Mine Name: Cottonwood/Wilberg Mine County: Emery Permit Number: ACT/015/019

INSPECTION REPORT

Partial: XXX	Complete: Ex	ploration:_
Inspection Date & Time: 6	/27/2000 / 11:30a.r	n2:00p.m
	of Last Inspection

Figure 1

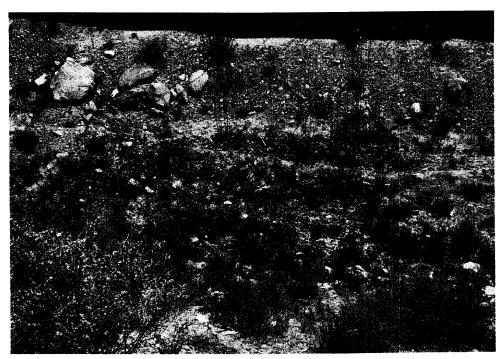
Some refuse material was observed outside of the containment berm at the waste rock storage site. This material needs to be retrieved and the area reseeded.(see Figure 1 below)
